2021 EXTERIOR FACADE
REPAIR PROJECT: PHASE I
CITYVIEW CO-OP
MINNEAPOLIS, MN

SHEET TITLE:
**STRUCTURAL
REPAIR
DETAILS**

STRUCTURAL ADDENDUM
05/12/2021

4.2

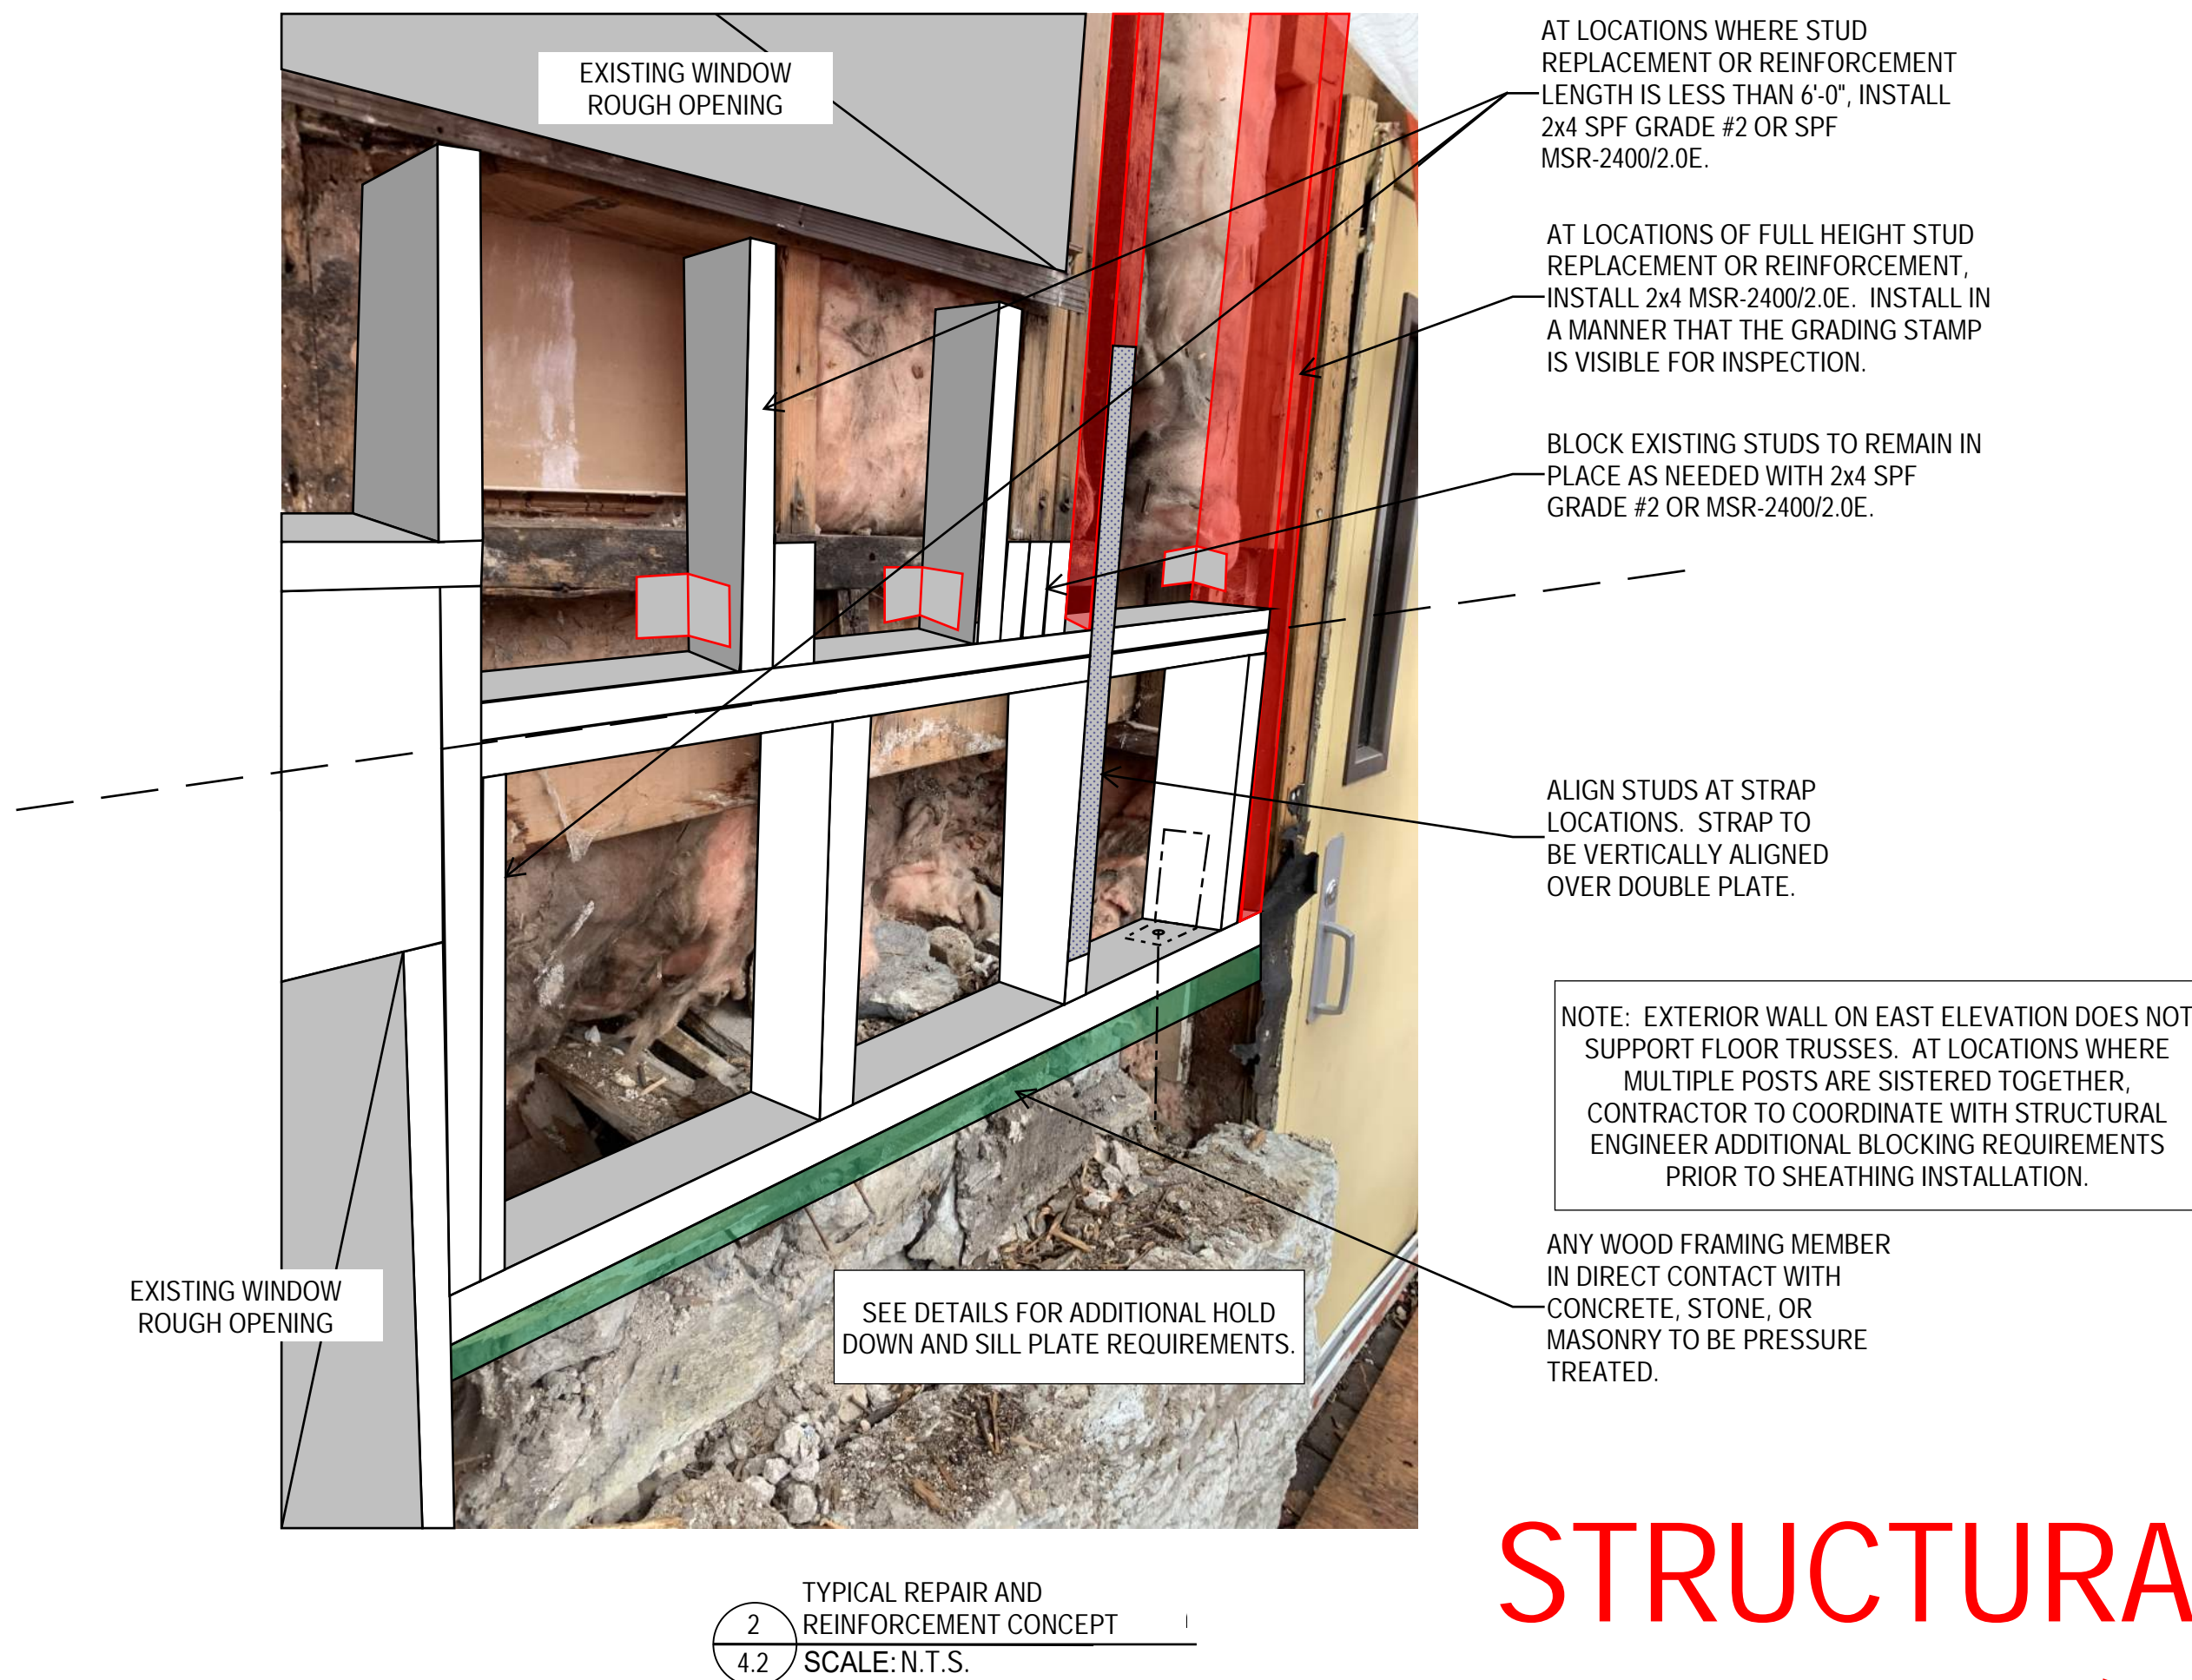
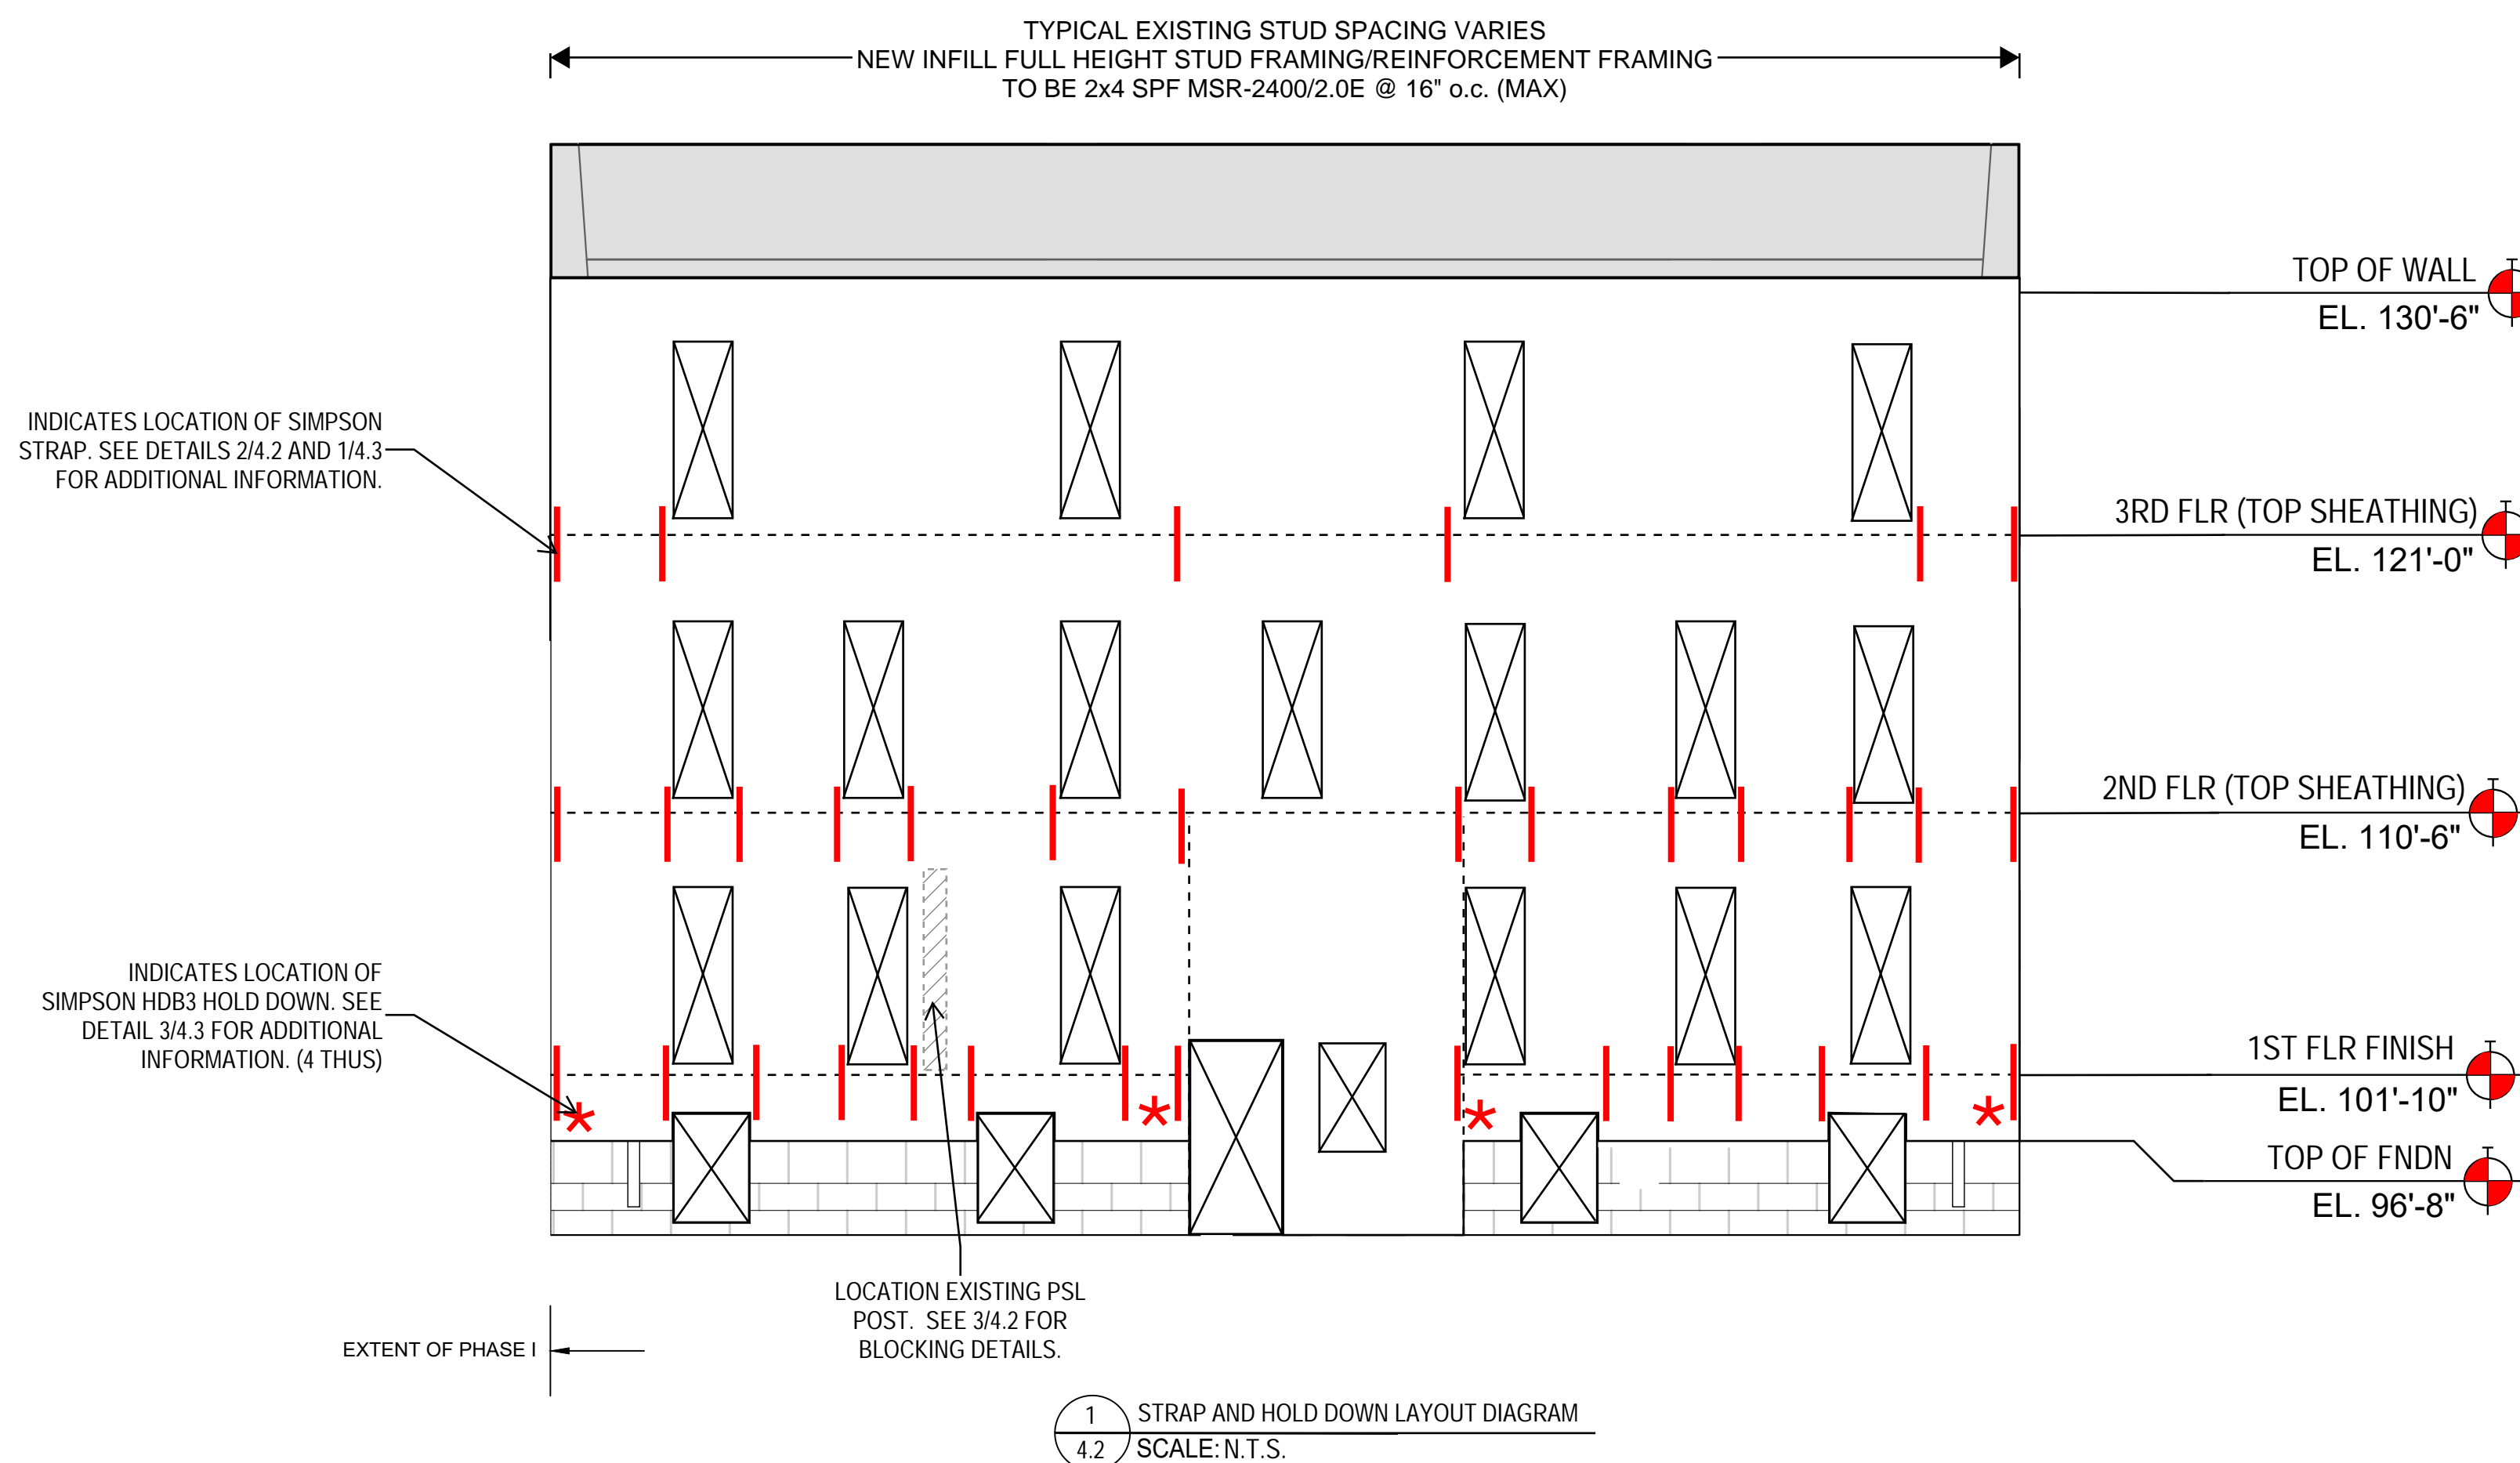
3. REPAIR TO CONSIST OF CUTTING AND REMOVING PORTIONS OF WATER DAMAGED STUD FRAMING AND REINFORCING EXISTING STUDS WITH 2x4 SPF MSR-2400/2.0E FULL HEIGHT STUDS. AT LOCATIONS WHERE FRAMING IS LESS THAN 6'-0" IN LENGTH, CONTRACTOR MAY SUBSTITUTE REINFORCEMENT WITH FULL HEIGHT 2x4 SPF #2 OR BETTER. REINFORCEMENT TO BE SISTERED TO SIDE OF EXISTING STUDS PER NDS RECOMMENDATIONS.

4. CONTRACTOR TO CUT EXISTING BALLOON FRAMING STUDS AT FLOOR LINES AND INSTALL A CONTINUOUS DOUBLE PLATE ALONG EACH FLOOR LINE.
5. CONTRACTOR TO ATTACH WALL FRAMING TO FLOOR DIAPHRAGM AT OR BELOW EXISTING FLOOR LINE WITH FRAMING CLIPS.

6. CONTRACTOR TO INSTALL STRAP AND HOLD DOWNS FOR LATERAL WIND LOAD DISTRIBUTION PER 1/4.2. STRAP AND HOLD DOWN LOCATIONS TO BE ALIGNED. CONTRACTOR TO INSTALL ADDITIONAL REINFORCEMENT FRAMING AND BLOCKING AS REQUIRED TO ALIGN STRAPS AND HOLD DOWNS.

7. ALL EXTERIOR SHEATHING ON THE EAST ELEVATION TO BE REPLACED WITH 7/16" APA RATED EXTERIOR SHEATHING, ORIENTED VERTICALLY WITH HORIZONTAL JOINTS BLOCKED. PLYWOOD WALL PANELS SHALL BE ORIENTED WITH FACE GRAIN PARALLEL TO SUPPORT STUD.
